# SCI-823-0.00

## S.R. 823 OVER MORRIS LANE BLUE RUN ROAD

### STRUCTURE TYPE STUDY SUBMITTAL

OHIO DEPARTMENT OF TRANSPORTATION

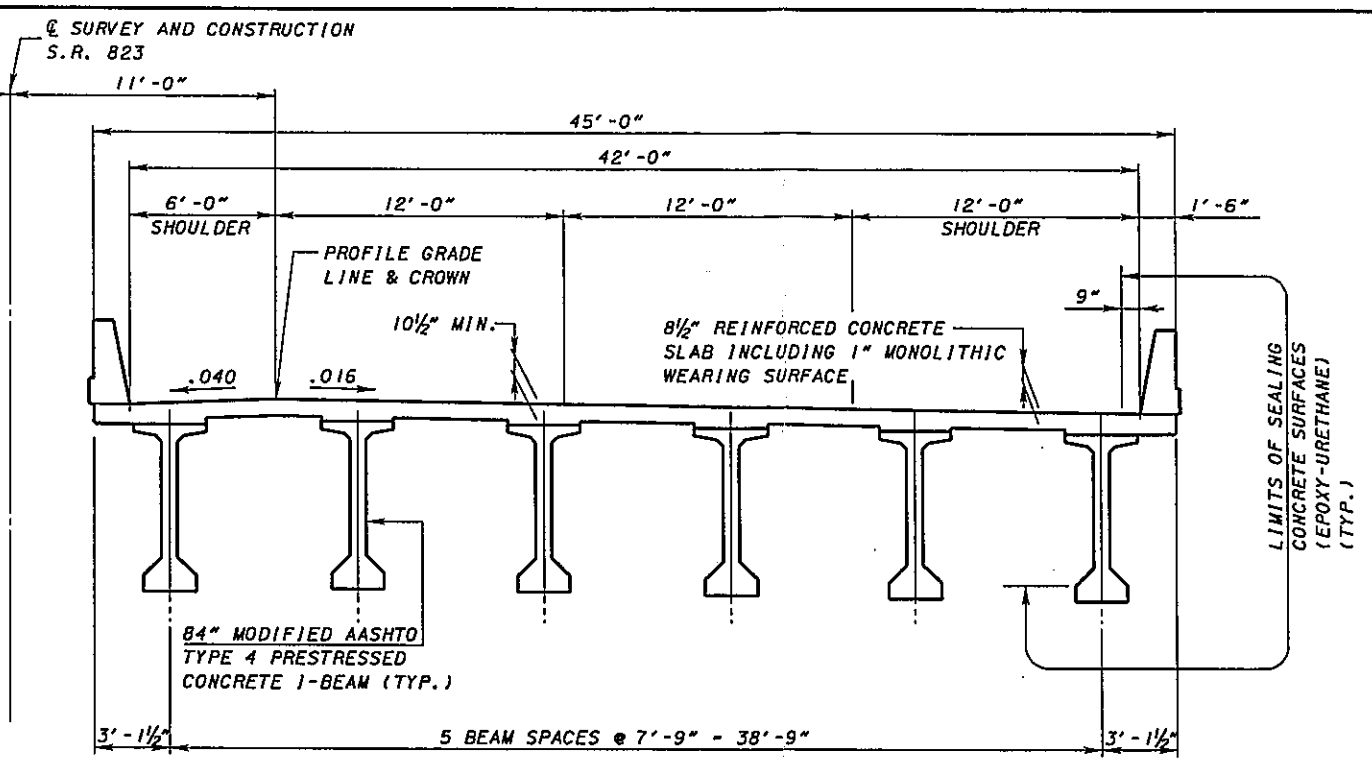
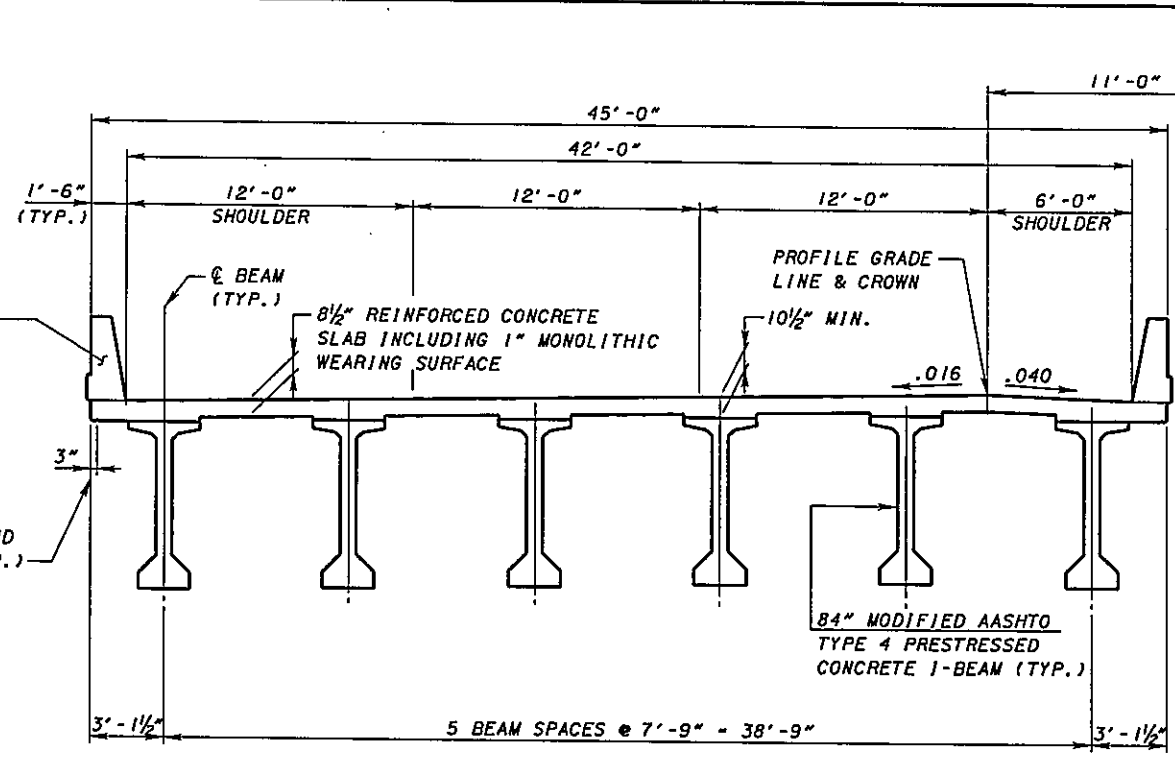
*Cost analysis for all possible structure types??*  
*Reanger Punched holes with H-piles*  
*Ask about MSE Wall Costs*
